# URGENT - Field Safety Notice

## Liver Assist Perfusion Set

# URGENT - Field Safety Notice (FSN)

### Quality defect – potential leakage of set

Figure 1: connections of the pump head

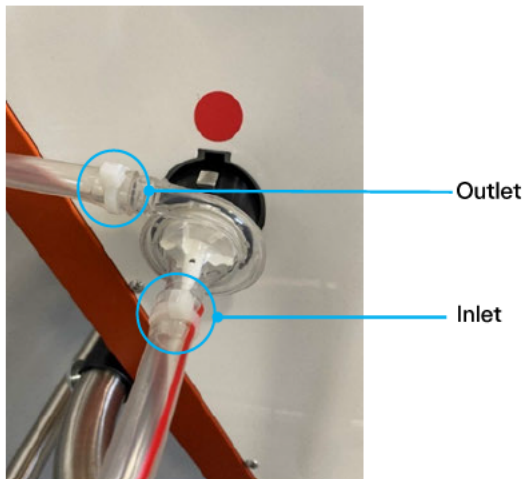
In rare cases, leakage could occur at the tubing connections of the pump head. Each perfusion set contains two pump heads with both an inlet and an outlet. The potential leakage can be determined already during priming when high pressures are applied. The leakage can be noticed by drop formation or persistent air bubbles at the tubing connections of the pump head

1. During priming, carefully check the connections at each pump head (4 in total). Check the inlet side for potential air bubbles in the solution or leakage. Also check the outlet side for potential leakage of solution. When handling the pump head do not extensively pull the tubing or connections.
2. If above issues are observed during priming, you can choose to replace the cable tie of the affected pump head or replace the full set.
3. If replacing the full set, save the affected set as it needs to be returned for investigation and refund.
4. If no leakages or persistent air bubbles are observed the perfusion set can be used as intended.

For an experienced user, the affected connection at the pump head can be improved by replacing the cable tie. This should take place before placing an organ on the device. Take notice that the recommended size of the new cable tie is smaller (3,5 mm instead of the current 4,6 mm).
